# PIC24FJ256DA210 FAMILY

## Silicon Errata Issues

## Data Sheet Clarifications

The following typographic corrections and clarifications are to be noted for the latest version of the device data sheet (DS39969B):

**FIGURE 2-3 FREQUENCY vs. ESR PERFORMANCE FOR SUGGESTED VCAP**

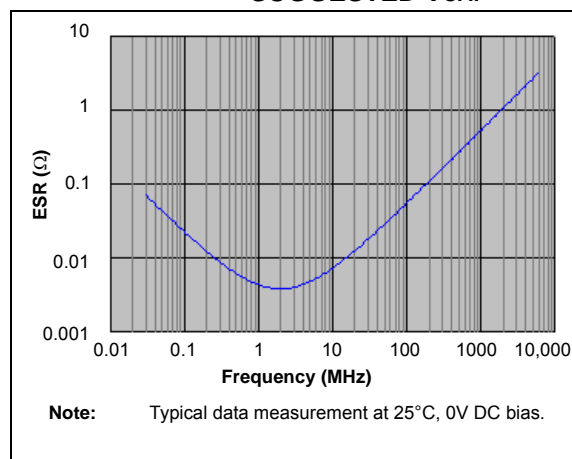
Section 2.4 Voltage Regulator Pins (ENVREG/DISVREG and VCAP/VDDCORE) has been replaced with a new and more detailed section. The entire text follows:

When the regulator is enabled, a low-ESR ( $< 5\Omega$ ) capacitor is required on the VCAP pin to stabilize the voltage regulator output voltage. The VCAP pin must not be connected to VDD and must use a capacitor of 10  $\mu\text{F}$  connected to ground. The type can be ceramic or tantalum. Suitable examples of capacitors are shown in [Table 2-1](#). Capacitors with equivalent specifications can be used.

Designers may use [Figure 2-3](#) to evaluate ESR equivalence of candidate devices.

The placement of this capacitor should be close to VCAP. It is recommended that the trace length not exceed 0.25 inch (6 mm). Refer to **Section 30.0 “Electrical Characteristics”** for additional information.

**FIGURE 2-4 DC BIAS VOLTAGE vs. CAPACITANCE CHARACTERISTICS**

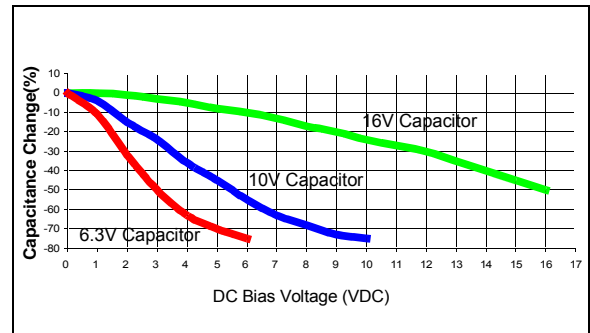
In addition to temperature tolerance, the effective capacitance of large value ceramic capacitors can vary substantially, based on the amount of DC voltage applied to the capacitor. This effect can be very significant, but is often overlooked or is not always documented.

A typical DC bias voltage vs. capacitance graph for 16V, 10V and 6.3V rated capacitors is shown in Figure 2-4.

When selecting a ceramic capacitor to be used with the internal voltage regulator, it is suggested to select a high-voltage rating, so that the operating voltage is a small percentage of the maximum rated capacitor voltage. For example, choose a ceramic capacitor rated at 16V for the 1.8V  $V_{\text{CAP}}$  voltage. Suggested capacitors are shown in Table 2-1.

**FIGURE 30-1: PIC24FJ256DA210 FAMILY VOLTAGE-FREQUENCY GRAPH (INDUSTRIAL)**

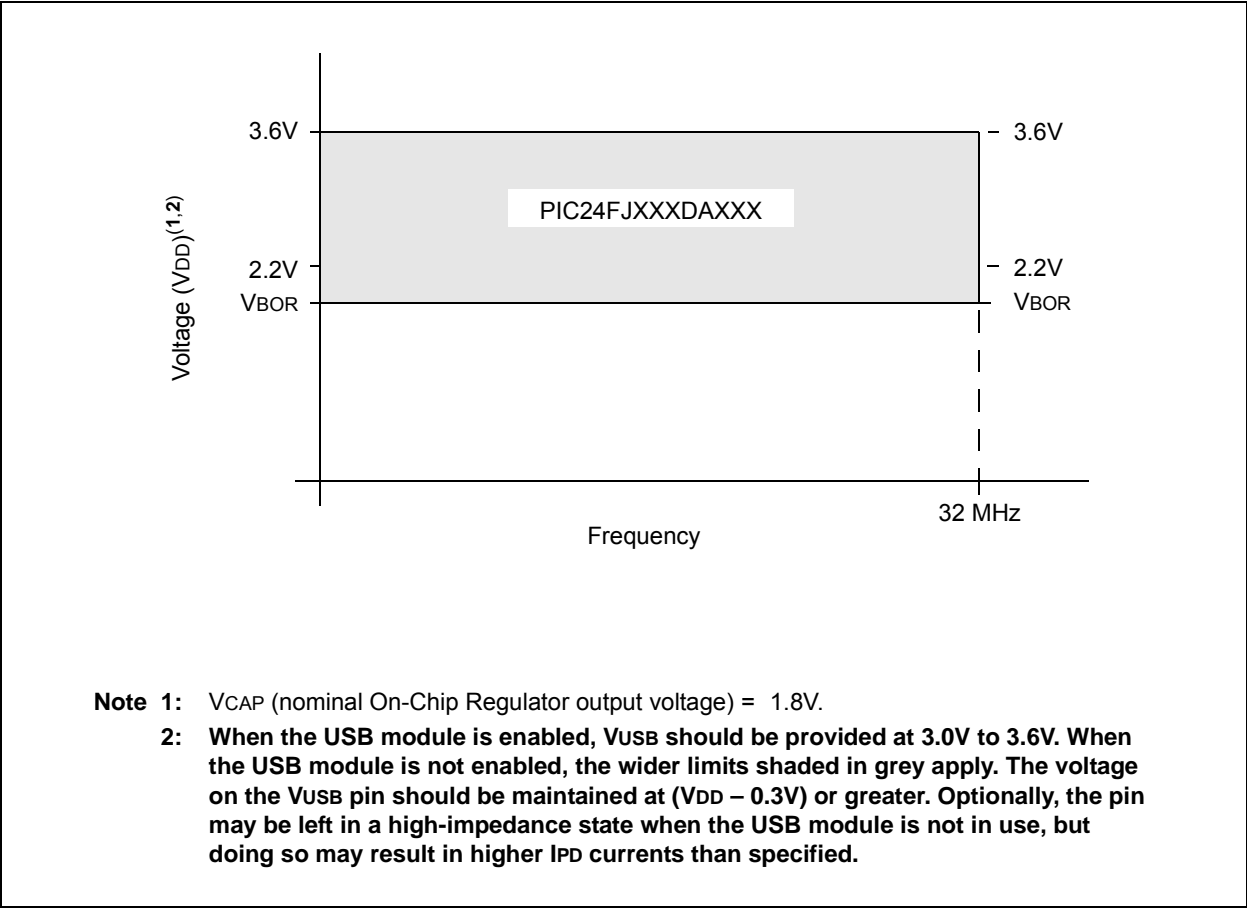
Figure 30-1 (“PIC24FJ256DA210 Family Voltage-Frequency Graph”) is amended by adding an additional footnote. The updated figure is shown below (changes in **bold**; bold in original removed for clarity).
